Stop Use & Product Recall

3M™ PROTECTA® Cobra Rope Grab AC202D

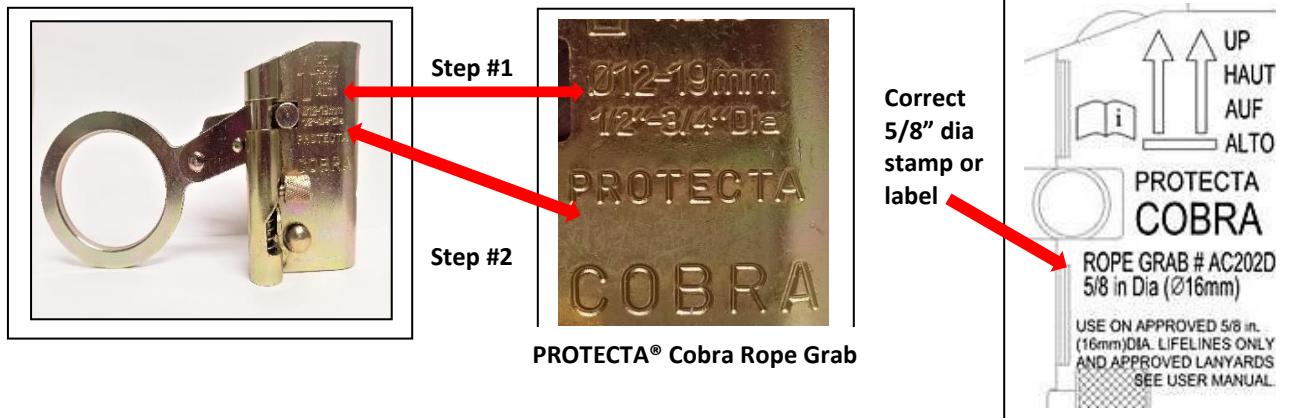
3M Fall Protection has determined that the 3M™ PROTECTA® Cobra Mobile/Manual Rope Grab AC202D is incorrectly stamped for use with 1/2 to 3/4 inch diameter rope on the exterior body of the unit. This Cobra Rope Grab is certified for use **ONLY** with 5/8 inch diameter polyester or polypropylene rope. All marketing information and the Instructions for Use (IFU) for this rope grab correctly identify the size of rope to be used as 5/8 inch polyester/polypropylene rope.

Step 1: Verify the rope diameter is stamped **1/2"—3/4" Dia** on the front side of the unit

Step 2: Verify the rope grab is stamped **PROTECTA COBRA** on the front side of the unit

Note: If the unit is stamped 5/8 inch diameter **OR** if the unit has a white label showing 5/8 inch diameter, then the unit is safe to return to normal use (see image on right for correct 5/8" diameter marking).

If the information in Step 1 and Step 2 is stamped onto the side of the rope grab as illustrated above, remove the unit from service immediately. Owners of AC202D Cobra Rope Grabs can choose one of the following options for each affected rope grab they own:

1. A free, new, properly marked replacement AC202D Cobra Rope Grab; or
2. A full credit.
